**DOCUMENT 00 90 00**  
**ADDENDUM**

**ADDENDUM No.:** 2

**RE:** HOUSING AUTHORITY OF THE CITY OF LA CROSSE  
2024 SMOKE ALARMS  
LA CROSSE, WISCONSIN 54601  
PROJECT NO. 24034

**3 BASEMENT PLAN**  
1/8" = 1'-0"

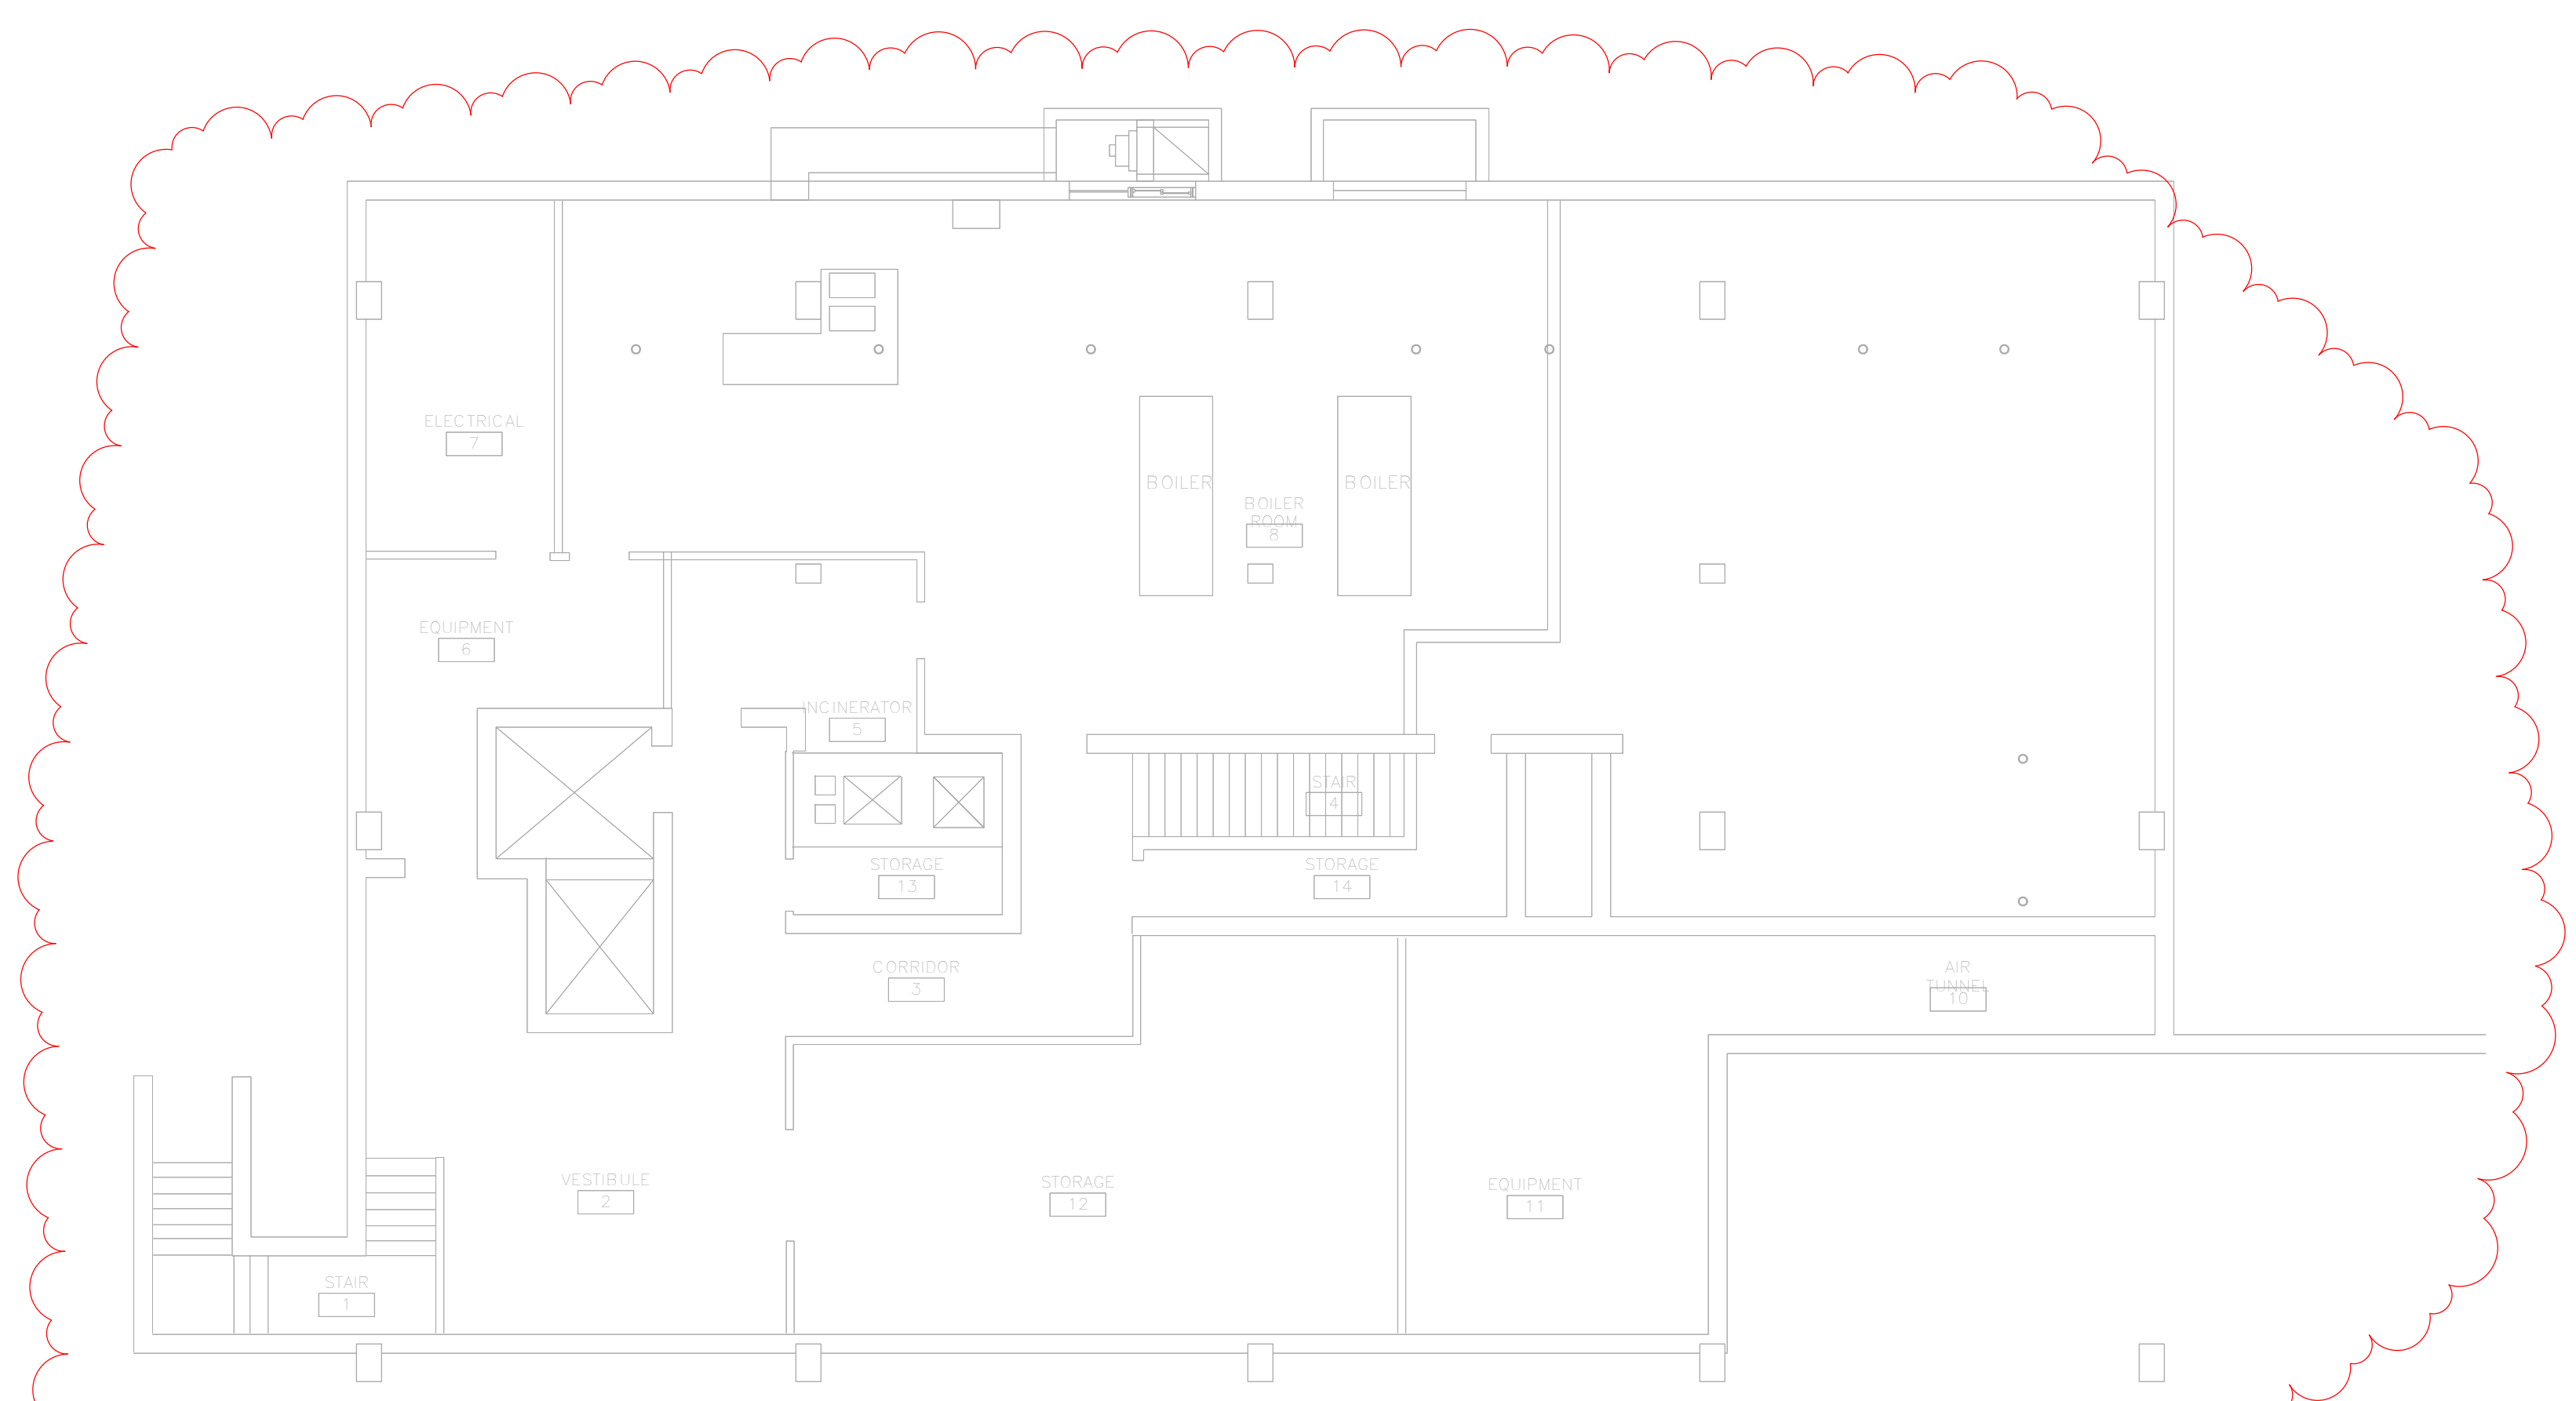
- d. Revised clouded plan views to remove wiring and conduit.
  - e. Added photo to show an example unit interior.
  - f. Added plan 3E501 to include a basement location in the project scope.
